# Access Compliance Report

## Public Rights-of-Way

### (Curb Ramps)

Intersection ID: 14036	Main Street: COMMONWEALTH_AV	Cross Street: MORNINGSIDE_DR	Location:	N
ADA ID: 11608AFB93F1	Ramp Type: Perp	Initial Pass/Fail: Fail	Overall Compliance: No	Severity Score: 13.75
Codes/Mitigation Info/Possible Solution		Field Measurements/Component Compliance

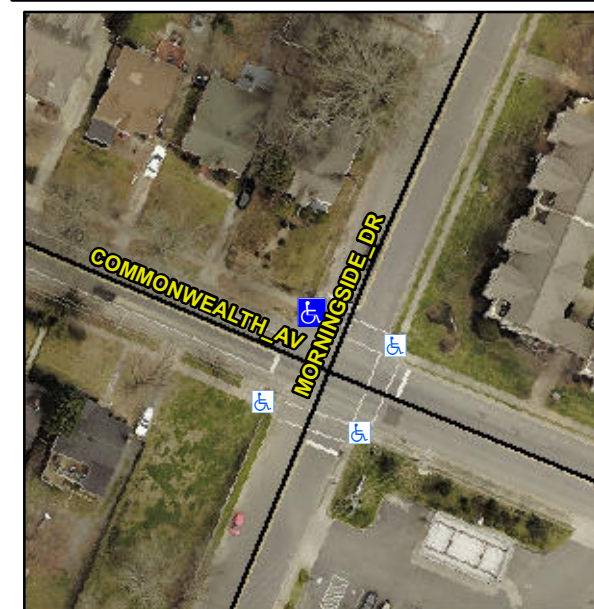
**Not Found, R304.2.2, R304.5.3**

Compliance	Description	Data	Compliance	Description	Data
N/A	Ramp Length (in)	77.0	No	Ramp Slope (%)	10.5
Yes	Ramp Width (in)	48.0	No	Ramp XSlope (%)	2.7
N/A	Flare Type LT	N/A	N/A	Flare Type RT	N/A
N/A	Flare Slope LT (%)	N/A	N/A	Flare Slope RT (%)	N/A
N/A	Flare Traversable LT?	N/A	N/A	Flare Traversable RT?	N/A
N/A	Landing Length (in)	N/A	N/A	DWS Provided?	N/A
N/A	Landing Width (in)	N/A	N/A	DWS Contrast?	N/A
N/A	Landing Slope (%)	N/A	N/A	DWS Length (in)	N/A
N/A	Landing X Slope (%)	N/A	N/A	DWS Full Width?	N/A
N/A	Landing Curb? (Y/N)	N/A	N/A	DWS Offset (in)	N/A
N/A	Shared Landing?	N/A			
N/A	Gutter Ponding?	N/A	N/A	Gutter Slope (%)	N/A
N/A	Gutter Lip Ht (in)	N/A	N/A	Gutter X Slope (%)	N/A
N/A	Painted X Walk1?	Yes	N/A	Painted X Walk2?	N/A
	X Walk 1 Direction	To SE		X Walk 2 Direction	N/A
N/A	X Walk 1 Width (in)	117.0	N/A	X Walk 2 Width (in)	N/A
	X Walk 1 Slope (%)	2.7		X Walk 2 Slope (%)	N/A
	X Walk 1 X Slope (%)	0.2		X Walk 2 X Slope (%)	N/A

**Remove & Replace Entire Ramp.**
